Final Environmental Assessment/Habitat Conservation Plan for  
Issuance of a Section 10 (a)(1)(B) Permit for Incidental Take of the Barton Springs  
Salamander (*Eurycea sosorum*) for the Operation and Maintenance of Barton Springs  
Pool and Adjacent Springs  
City of Austin, Texas

October 1998

APPENDIX D - Public Comments

Figure 4: Location of proposed water control structure in Barton Springs Pool

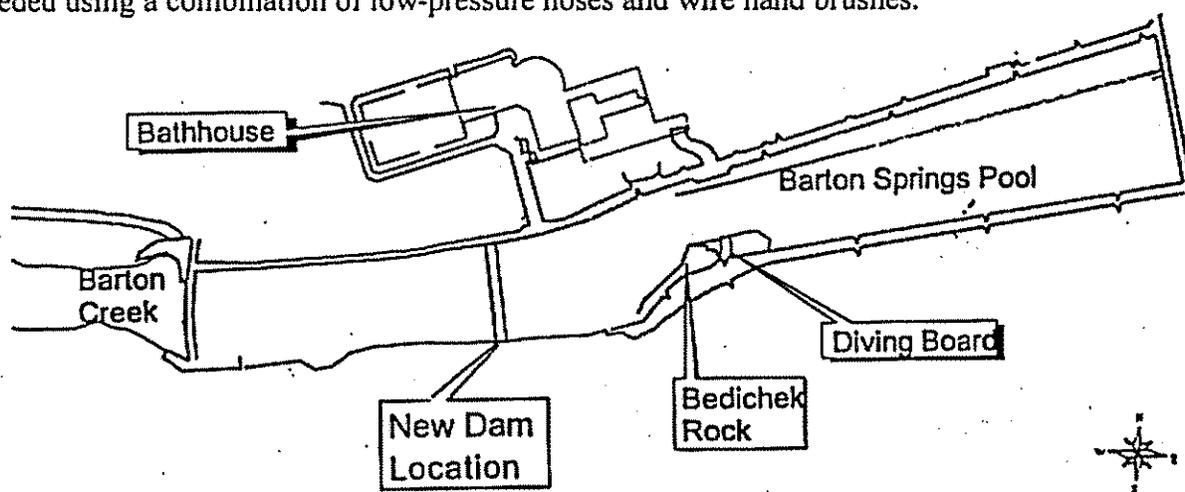
**You should take short steps at a time, rather than making many modifications at once. Rather than putting a three-foot high dam, just building a low-height structure (10-15 in. off the bottom) would do what needs to be done during drawdowns to clean the shallow end.**

- ❖ **With the new proposed location of the dam, the dam must be removable or swimmers will be impeded. A permanent dam with wide spaces for passage of swimmers would not be effective. A logjam of swimmers frequently occurs at the proposed location of the dam with nothing there now. The new location is preferable to the 1/8-mile marker provided swimmers have unimpeded swim space. This location is preferable because more shallow area can be cleaned. However, an unimpeded swim space could only occur with a removable dam. Create a permanent "team" to install the dam and to remove it at cleanings. This team could be from Public Works or from PARD operations. Do not use lifeguards for this work. It should not be their job and if some other entity has the responsibility, then PARD should not object to a removable dam. The team could be funded from Barton Springs Pool revenue.**
